# Product Support Bulletin 2003-013

## Maintenance of Way ~ Work Equipment Bulletin

**SUBJECT:** Clevis-style Pusher Block Links - 47706087

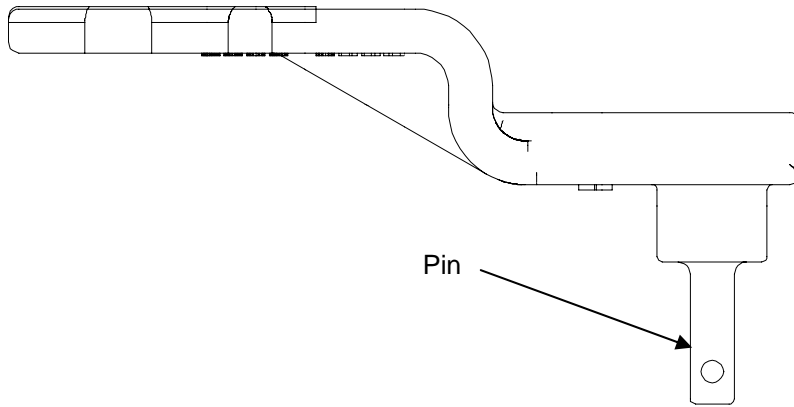
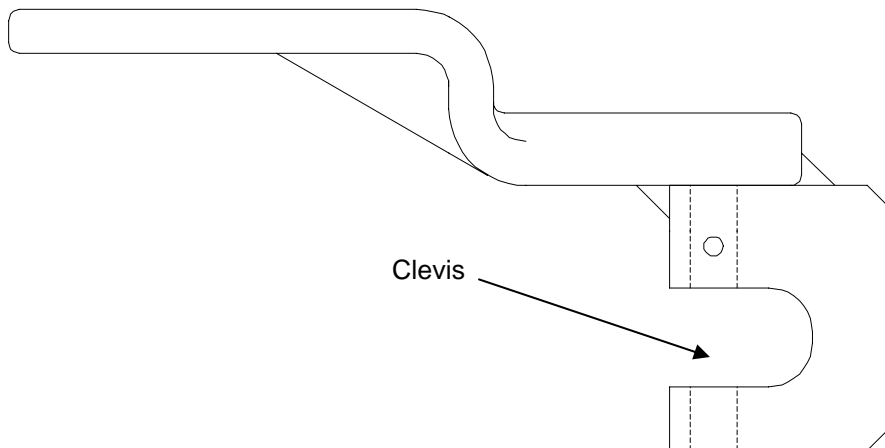
**SUMMARY:** A **Clevis-style Pusher Block Link, p/n 47706087**, has been designed to replace the Pin-style Pusher Block Link, p/n 47706083, used on these machines. The pin on the link could break during use allowing the Feeder Cylinder Rod to come out of the cylinder barrel.

**OPERATIONAL IMPACT:** The new link will prevent damage to the Feeder Cylinders, p/n 96350523, caused if the pin on the link breaks. The cylinder attaches to the new link with a clevis pin. This pin is supported on both sides of the cylinder rod, eliminating the side load problem of the original design.

**ACTION:** The new links are directly interchangeable with the original links. Each link is shipped with a **Clevis Pin, p/n 3301127** and **Cotter Pin, p/n 3070159**. This new link will be supplied on all parts orders and is standard on all Model CX Spike Drivers starting with S/N 410501. The original Pin-style Links are no longer available.
